TRANSMITTAL COVER SHEET

DATE: 25 June 2024
TO: ALL PLAN HOLDERS OF RECORD
FROM: HUNTER SWATEK, AIA, PROJECT MANAGER
PROJECT: RAINBOW CITY RECREATION CENTER
GMC PROJECT NO. ABHM230021
RE: ADDENDUM NO. 4 AND
ACKNOWLEDGEMENT OF RECEIPT OF ADDENDUM NO. 4

ADDENDUM NUMBER 04

**PROJECT: RAINBOW CITY RECREATION CENTER
GM&C PROJECT NO. ABHM230021**

G1 AMPHITHEATRE PLAN
SCALE: 1/4" = 1'-0"

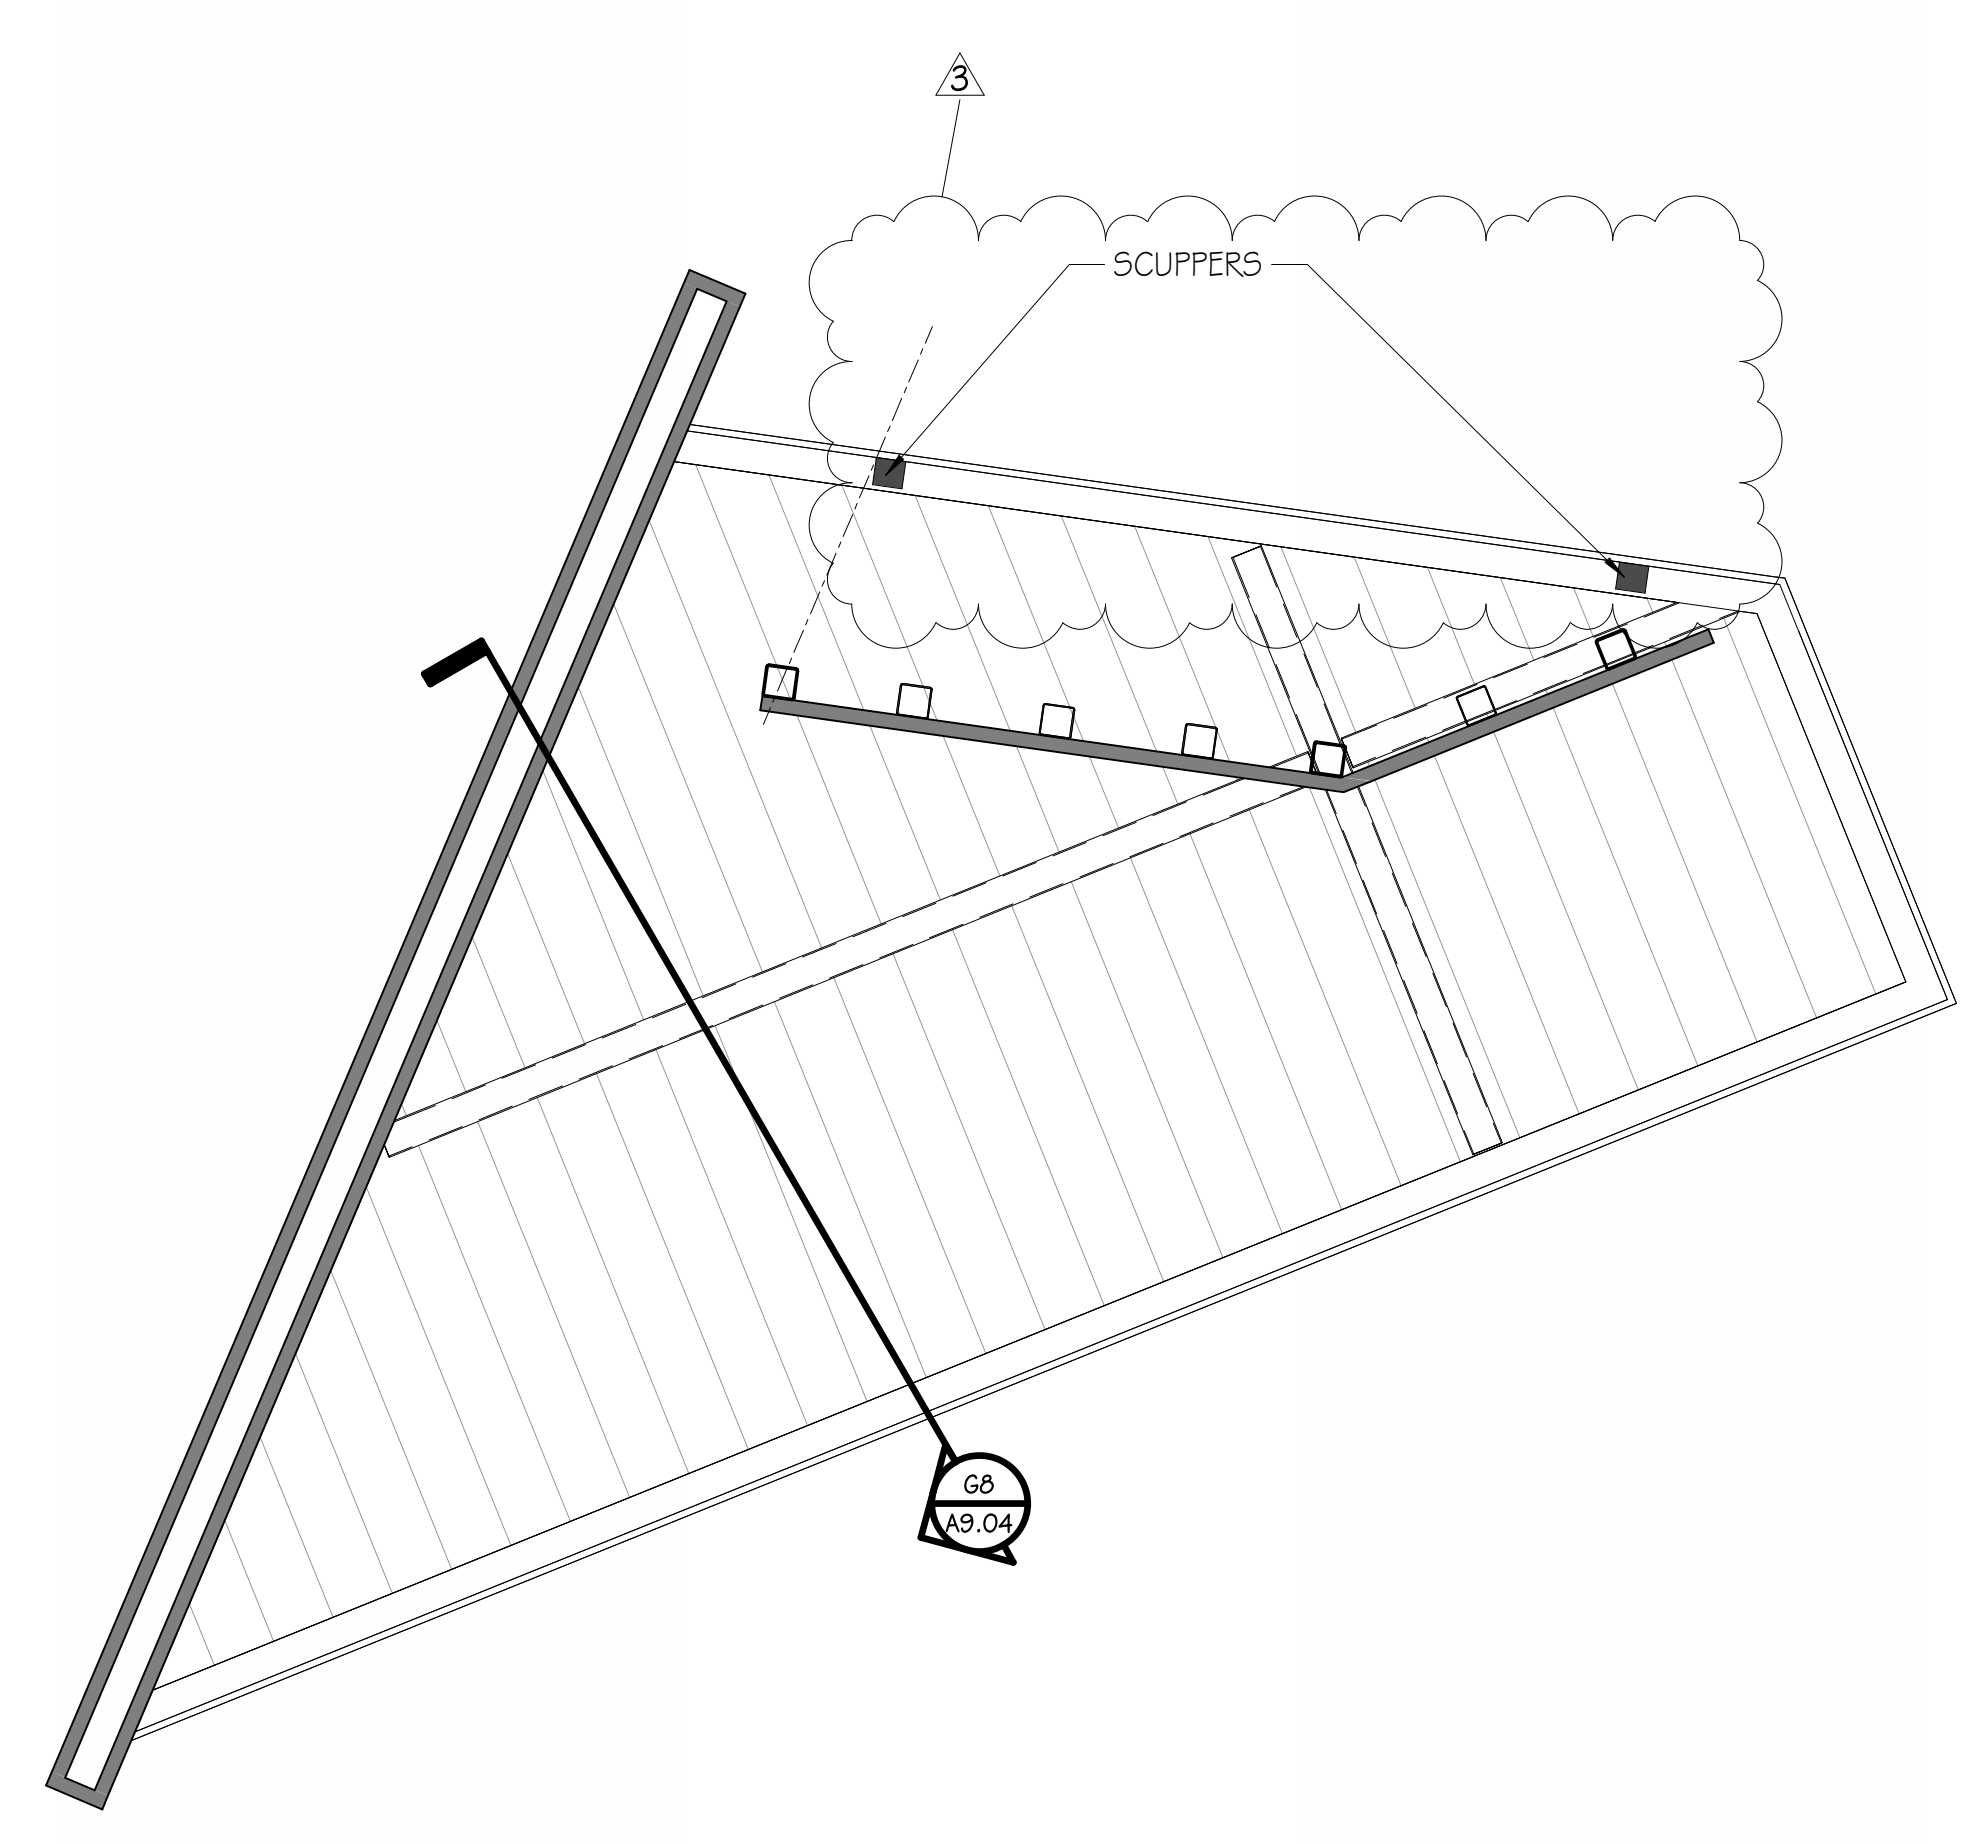
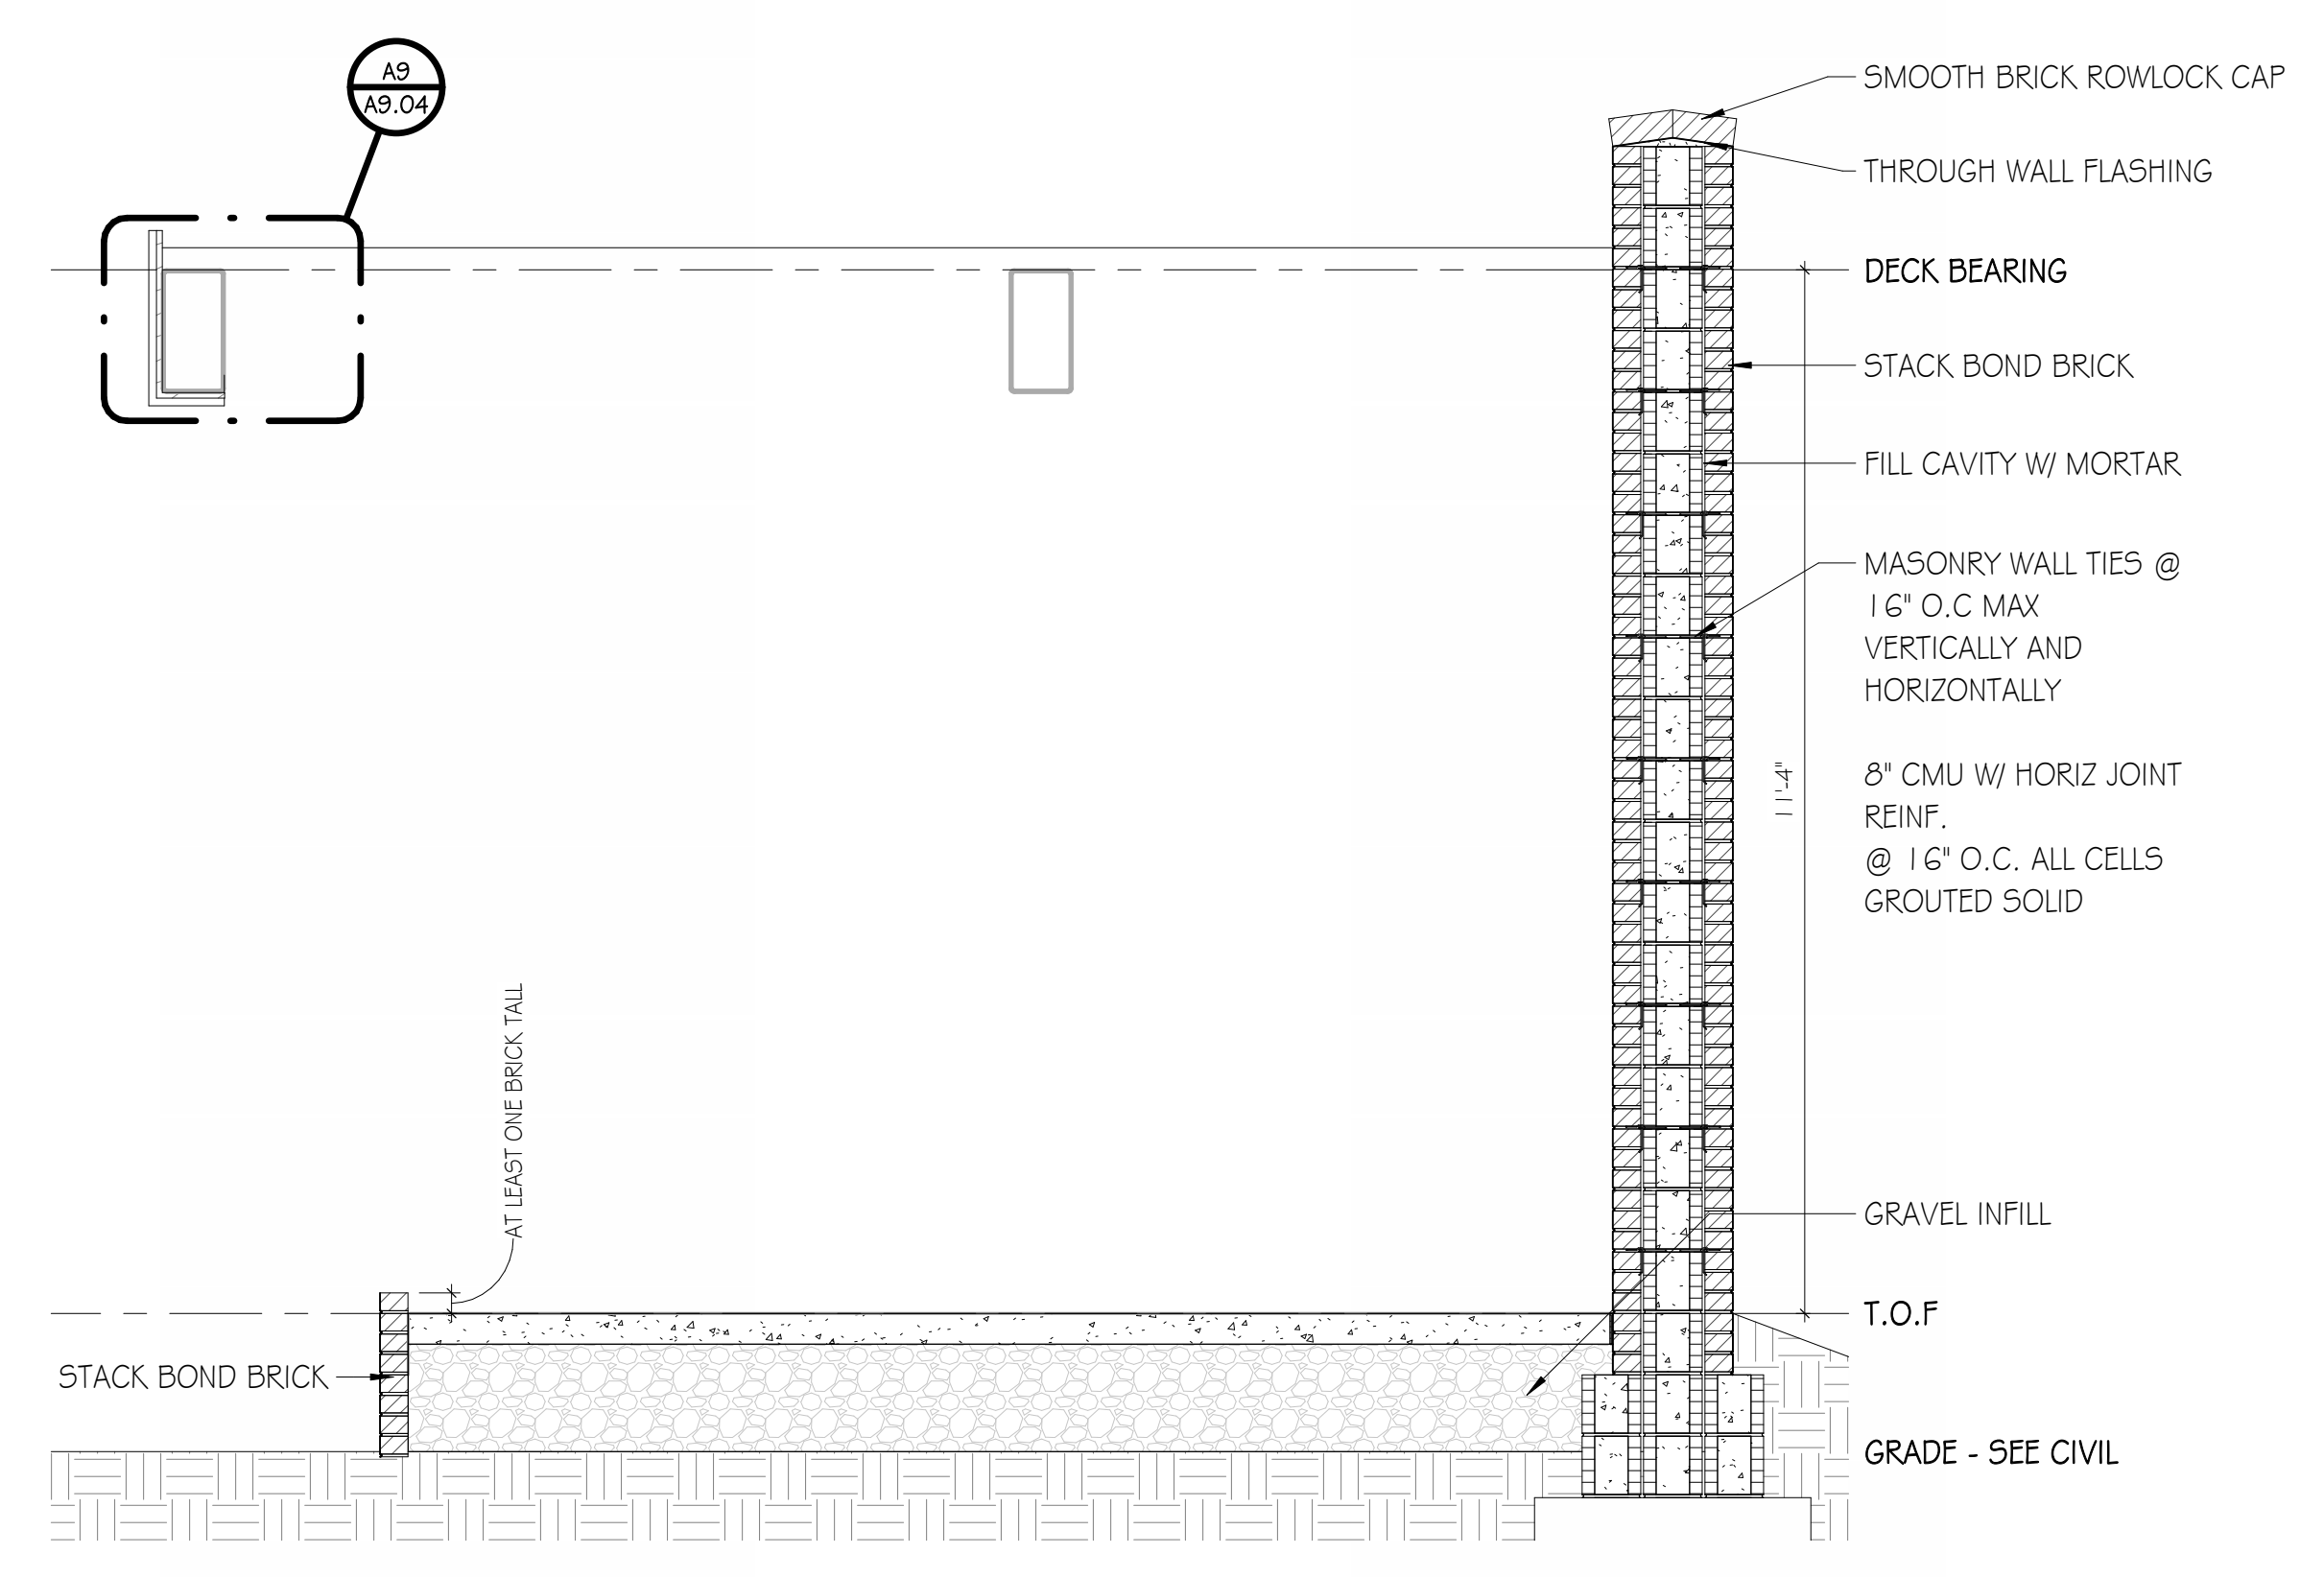
- a. ADDED TV Enclosure
- F. **A7.06** – Gym Interior
 - a. ADDED TV Enclosure
- G. **A7.07** – Interiors Multi-Purpose
 - a. REVISED Acoustics Pattern
- H. **A9.04** – Amphitheatre

- a. ADDED Scuppers
- I. **C-101** – Site plan
 - a. REVISED Transformer Pad Location
- J. **C-201** – Grading Plan
 - a. REVISED Note
- K. **L1.01** – Materials Plan
